IB12-J-004B

EGR Cooler Stress Crack - Service Procedure Reminder

This bulletin supersedes IB12-J-004A. This bulletin is being revised to update Model Years. Please discard bulletin IB12-J-004A.

Cracked EGR Cooler from 7.8L 6HK1

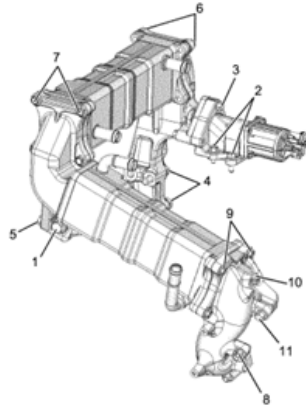
Some customers may experience exhaust leaks, loss of coolant or overheating condition after a recent repair to one or both EGR Coolers. Isuzu investigation of returned EGR Coolers has found that the service replacement part installed was cracked at the mounting flange area as a result of excessive stress. This stress was found to be created by the improper torquing sequence and torque amount during the repair.

IMPORTANT: Follow the "EGR Cooler Replacement" procedure in the service manual. Not following the service manual torque procedure will result in EGR Cooler cracking.

5.2L 4HK1 (2007-2010MY)

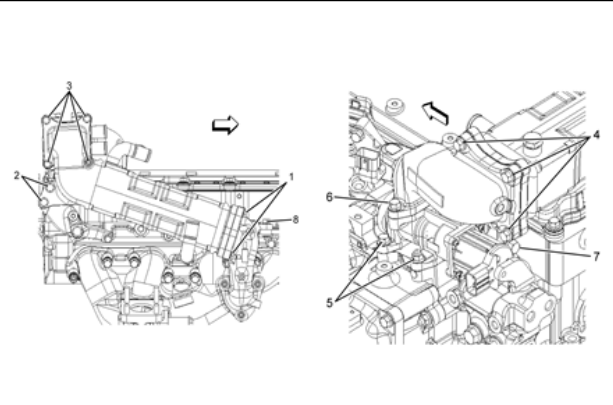
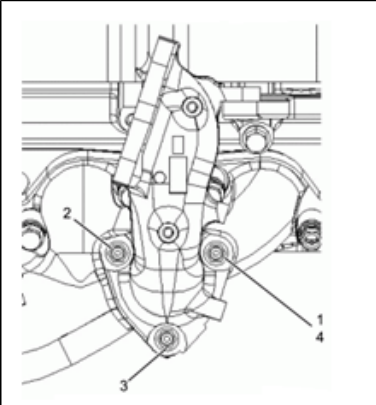
When replacing one or both EGR coolers, loosen all of the EGR-related bolts, including the side that is not being replaced. Follow the 2-step process, temporarily tighten then final torque in the sequence below, for proper installation. See the service manual for additional information.

Step One
Tighten and torque in the following sequence:

- 1. Hand tighten
- 2. Hand tighten
- 3. Hand tighten
- 4. Hand tighten
- 1. 35 Nm (26 lb ft)
- 2. 35 Nm (26 lb ft)
- 3. 35 Nm (26 lb ft)
- 4. 35 Nm (26 lb ft)

5.2L 4HK1 (2007-2010MY)
Step Two
Torque in the following sequence:

- 1. 4 Nm (35 lb in)
- 2. 4 Nm (35 lb in)
- 3. 4 Nm (35 lb in)
- 4. 4 Nm (35 lb in)
- 5. 4 Nm (35 lb in)
- 6. 4 Nm (35 lb in)
- 7. 4 Nm (35 lb in)
- 8. Hand tighten
- 9. Hand tighten
- 10. Hand tighten
- 11. Hand tighten

- 1. 104 Nm (77 lb ft)
- 2. 24 Nm (17 lb ft)
- 3. 24 Nm (17 lb ft)
- 4. 104 Nm (77 lb ft)
- 5. 40 Nm (30 lb ft)
- 6. 28 Nm (21 lb ft)
- 7. 28 Nm (21 lb ft)
- 8. 35 Nm (26 lb ft)
- 9. 28 Nm (21 lb ft)
- 10. 40 Nm (30 lb ft)
- 11. 35 Nm (26 lb ft)
